Access Compliance Report

Public Rights-of-Way

(Pedestrian Signals)

Intersection ID: N/A	Main Street:	Cross Street: N/A	Location: N/A
ADA ID: 8F66AFCBDD7D	Signal Type: One Push Button-APS	Overall Compliance: No	Severity Score: BTN 1: N/A BTN 2: N/A No BTN: N/A
Codes/Mitigation Info/Possible Solution		Field Measurements/Component Compliance

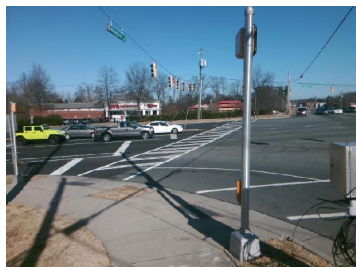
PROW/ADA: TMUTCD 4e.08, R404.2, R404.3, R406.2, R404.7.2, R209.1, MUTCD 4e.10

Compliance	Description	Data	Compliance	Description	Data
	Button Count	Button1	Yes	Distant to Additional Button (in)	440.0
	Additional Button Present?	Yes		Additional Button ID	02D44BAC203C
N/A	Signal Buttons Required?	N/A	N/A	Additional Ped Posts Required	N/A
	How Many Ped Street Xings?	N/A		Located In An Island/Median?	N/A
N/A	B 1 Sign Present?	Yes	N/A	B 2 Sign Present?	N/A
Yes	B 1 Sign Purpose?	Yes	N/A	B 2 Sign Purpose?	N/A
Yes	B 1 Sign Lettering & Contrast?	Yes	N/A	B 2 Sign Lettering & Contrast?	N/A
Yes	B 1 Parallel To XWalk?	Yes	N/A	B 2 Parallel To XWalk?	N/A
Yes	B 1 PAR to Button?	Yes	N/A	B 2 PAR to Button?	N/A
Yes	B 1 PAR to XWalk?	Yes	N/A	B 2 PAR to XWalk?	N/A
Yes	B 1 Clear Floor Space?	Yes	N/A	B 2 Clear Floor Space?	N/A
N/A	B 1 FWD Approach?	Yes	N/A	B 2 FWD Approach?	N/A
N/A	B 1 FWD Approach Constrained?	Yes	N/A	B 2 FWD Approach Constrained?	N/A
No	B 1 FWD Approach Reach (in)	6.5	N/A	B 2 FWD Approach Reach (in)	N/A

Yes	B 1 FWD Approach Width (in)	48.0	N/A	B 2 FWD Approach Width (in)	N/A
N/A	B 1 FWD Approach Obstruction?	Yes	N/A	B 2 FWD Approach Obstruction?	N/A
N/A	B 1 FWD Approach Obstruction Dist (in)	1.0	N/A	B 2 FWD Approach ObstructionDist (in)	N/A
N/A	B 1 PARA Approach?	Yes	N/A	B 2 PARA Approach?	N/A
N/A	B 1 PARA Approach Constrained?	Yes	N/A	B 2 PARA Approach Constrained?	N/A
Yes	B 1 PARA Approach Reach (in)	6.5	N/A	B 2 PARA Approach Reach (in)	N/A
No	B 1 PARA Approach Width (in)	48.0	N/A	B 2 PARA Approach Width (in)	N/A
N/A	B 1 PARA Approach Obstruction?	Yes	N/A	B 2 PARA Approach Obstruction?	N/A
N/A	B 1 PARA Approach Obstruction Dist (in)	1.0	N/A	B 2 PARA Approach ObstructionDist (in)	N/A
No	B 1 Clear Floor Space Slope (%)	2.8	N/A	B 2 Clear Floor Space Slope (%)	N/A
No	B 1 Clear Floor Space XSlope (%)	15.0	N/A	B 2 Clear Floor Space XSlope (%)	N/A
N/A	B 1 PAR Slope (%)	N/A	N/A	B 2 PAR Slope (%)	N/A
Yes	B 1 Height (in)	32.5	N/A	B 2 Height (in)	N/A

N/A	B 1 Clear Xing Direction?	Yes	N/A	B 2 Clear Xing Direction?	N/A
	B 1 Crossing Direction	To SE		B 2 Crossing Direction	N/A
No	B 1 DistanceTo XWalk (in)	77.0	N/A	B 2 DistanceTo XWalk (in)	N/A
Yes	B 1 DistanceTo Curb (in)	44.0	N/A	B 2 DistanceTo Curb (in)	N/A
Yes	B 1 Diameter (in)	2.0	N/A	B 2 Diameter (in)	N/A

Possible Solutions: Replace Signal Push Button With APS Button on New Post. Remove & Relocate Sign.
